STAFF RECOMMENDATION

1311 Shelby Avenue

May 15, 2013

Application: New Construction—Infill; Setback Reduction

B: Site Plan

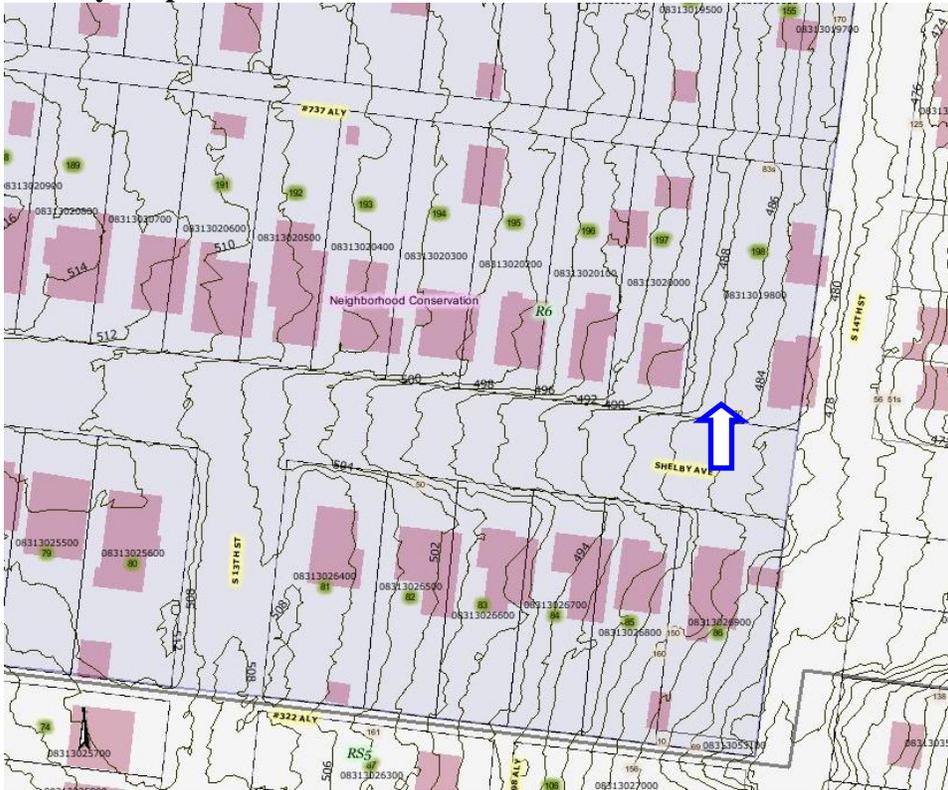
Setback and Rhythm of Spacing: The structure will be centered on the forty foot (40') wide lot. The majority of the structure will be five feet (5') from the side property lines. However, the two bays on both sides of the house will extend beyond the wall of the house by two feet (2'), and will be only three feet (3') from the side property lines. The new structure therefore requires a setback reduction. Staff finds that the setback reduction is appropriate in this instance because only the bays will sit beyond the setback line and the majority of the house will meet the required five foot (5') setback. In addition, historically it was not uncommon for houses, particularly those with bays, to sit closer to the side property lines than five feet (5').

The front wall of the house lines up with the front wall of the house to the left and is just slightly behind the front wall of the house at 1313 Shelby. The porches will extend just slightly beyond the line of the porch at 1313 Shelby, which staff believes to be appropriate.

Appurtenances & Utilities: The locations of the utilities and HVAC system were not indicated on the plan, and staff asks that they be located in the rear of the house or on a side façade, beyond the midpoint of the house. Uncovered concrete pads are proposed for the rear of the structure, and staff finds these to be appropriate. A central walkway leading from the sidewalk to the porches should be constructed. Staff finds that the known appurtenances meet Section II.B.9. of the *Lockeland Springs-East End Neighborhood Conservation Zoning Overlay Handbook and Design Guidelines*.

Elevations
Scale 1/8" = 1'

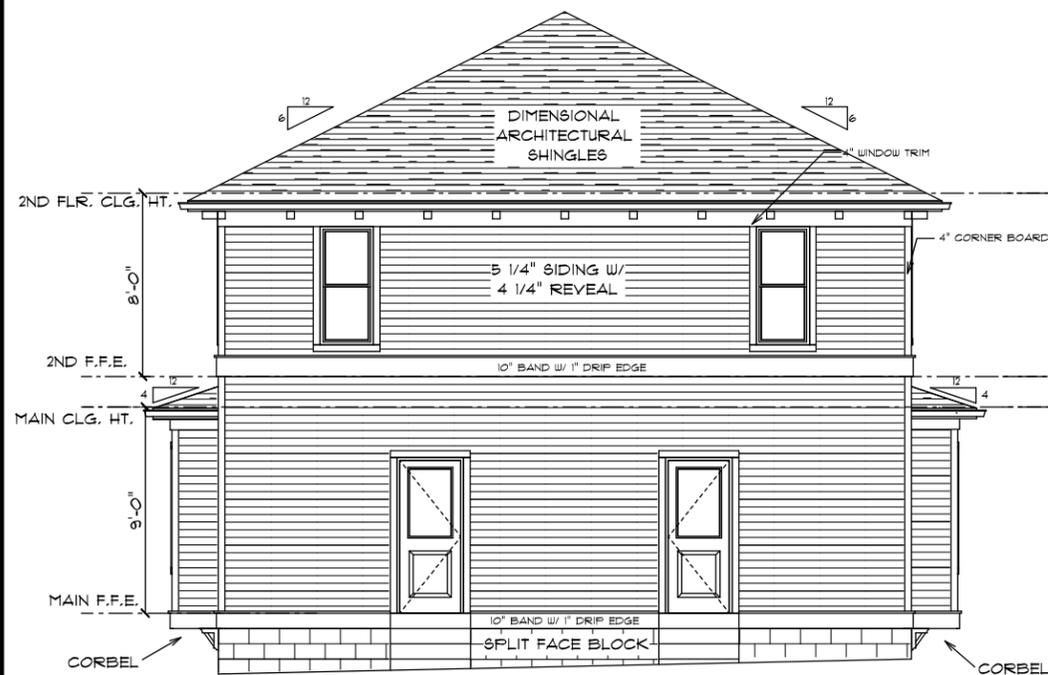
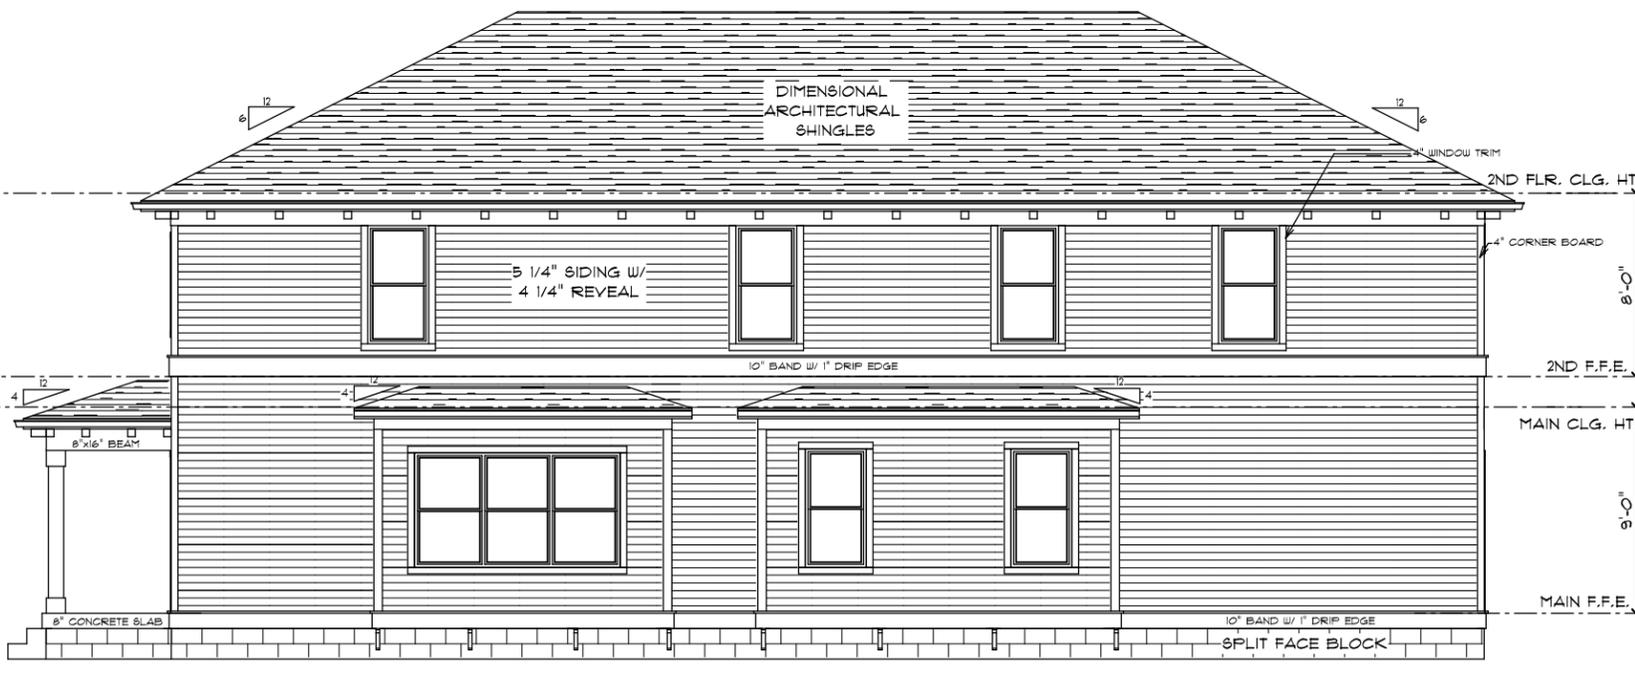
Orientation: The structure is oriented to face Shelby Avenue, as is appropriate. As a duplex, it has two entrances and two porches on the front façade. The two entrances are identical in design and are equal in dominance, as was commonly found on historic duplexes in Lockeland Springs. Staff finds that the structure's orientation meets Section II.B.6. of the *Lockeland Springs-East End Neighborhood Conservation Zoning Overlay Handbook and Design Guidelines*.

Height & Scale: The new structure will be two stories tall. It will have an eave height of approximately eighteen feet (18') above the foundation and a ridge height of approximately twenty-seven feet (27') above the foundation. The foundation height at the front varies because of the cross slope of the lot. Staff asks that a condition of approval be that the foundation be no more than three blocks high. From grade, the addition will have a maximum height of approximately twenty-nine feet (29'). The hipped roof form will help to minimize the perceived height of the structure.

Materials: The primary cladding material will be lap siding with a four and a quarter inch (4 $\frac{1}{4}$ "") reveal. The foundation will be split face concrete block, and the roof will be dimensional architectural shingles. Staff asks to approve the shingle color. The porch floor will be a concrete slab. The materials for the windows, doors, and porch columns and rack were not specified and staff asks to approve these materials prior to purchase

Roof: The primary roof form is a hipped roof with a slope of 6/12. The porch roof and the roofs of the side bays will be hipped with a 4/12 slope. The roof shapes and pitches are found on historic buildings throughout the district and so meet Section II.B.5. of the *Lockeland Springs-East End Neighborhood Conservation Zoning Overlay Handbook and Design Guidelines*.

Proportion and Rhythm of Openings: The windows of the proposed structure are approximately twice as tall as they are wide, and therefore meet the historic ratio of windows in the neighborhood. The windows on the second story of the front façade are smaller than those on the ground floor. The largest expanse of wall space without a window or door opening is sixteen feet (16'), but that expanse does not occur until the back portion of the house. Staff therefore finds that this expanse meets the design guidelines. Staff asks that all double and triple window openings on all facades have a four to six inch (4"-6") mullion in between them. With the addition of the mullions, staff finds that the window proportions and rhythm of openings meets Section II.B.7. of *Lockeland Springs-East End Neighborhood Conservation Zoning Overlay Handbook and Design Guidelines*.

1. The foundation be a maximum of three blocks high at the front.
2. Staff review the asphalt shingle color, window and door materials and specifications, and porch columns and rack materials prior to purchase and installation.
3. All double and triple window openings on all facades have a four to six inch (4"-6") mullion in between them.
4. The utilities and mechanicals be located in the rear of the property, or on a side façade beyond the midpoint of the house.
5. A central walkway leading from the sidewalk to the porches be added.
6. Staff review all other appurtenances not indicated on the plans.
